Access Compliance Report

Public Rights-of-Way

(Curb Ramps)

Intersection ID: 11659	Main Street: E_16TH_ST	Cross Street: N_DAVIDSON_ST	Location: W
ADA ID: F28944866A40	Ramp Type: PerpDiag	Initial Pass/Fail: Fail	Overall Compliance: No
		Severity Score: 22.5	
Codes/Mitigation Info/Possible Solution		Field Measurements/Component Compliance

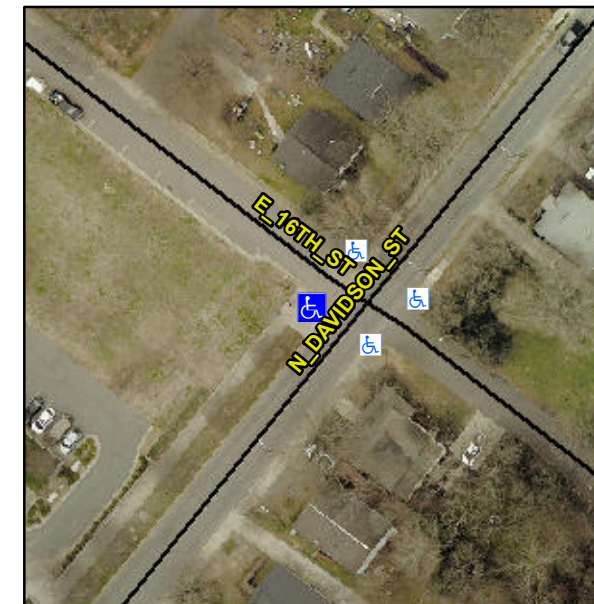
Not Found, R304.5.1, R304.2.2, R304.5.3

Compliance	Description	Data	Compliance	Description	Data
N/A	Ramp Length (in)	72.0	No	Ramp Slope (%)	9.3
No	Ramp Width (in)	47.5	No	Ramp XSlope (%)	2.8
N/A	Flare Type LT	N/A	N/A	Flare Type RT	N/A
N/A	Flare Slope LT (%)	N/A	N/A	Flare Slope RT (%)	N/A
N/A	Flare Traversable LT?	N/A	N/A	Flare Traversable RT?	N/A
N/A	Landing Length (in)	N/A	N/A	DWS Provided?	N/A
N/A	Landing Width (in)	N/A	N/A	DWS Contrast?	N/A
N/A	Landing Slope (%)	N/A	N/A	DWS Length (in)	N/A
N/A	Landing X Slope (%)	N/A	N/A	DWS Full Width?	N/A
N/A	Landing Curb? (Y/N)	N/A	N/A	DWS Offset (in)	N/A
N/A	Shared Landing?	N/A			
N/A	Gutter Ponding?	N/A	N/A	Gutter Slope (%)	N/A
N/A	Gutter Lip Ht (in)	1.5	N/A	Gutter X Slope (%)	N/A
N/A	Painted X Walk1?	No	N/A	Painted X Walk2?	No
	X Walk 1 Direction	To SE		X Walk 2 Direction	To NE
N/A	X Walk 1 Width (in)	N/A	N/A	X Walk 2 Width (in)	N/A
	X Walk 1 Slope (%)	1.3		X Walk 2 Slope (%)	2.7
	X Walk 1 X Slope (%)	1.6		X Walk 2 X Slope (%)	1.1

Remove & Replace Curb Ramp With Two New Directional Ramps or Equivalent.
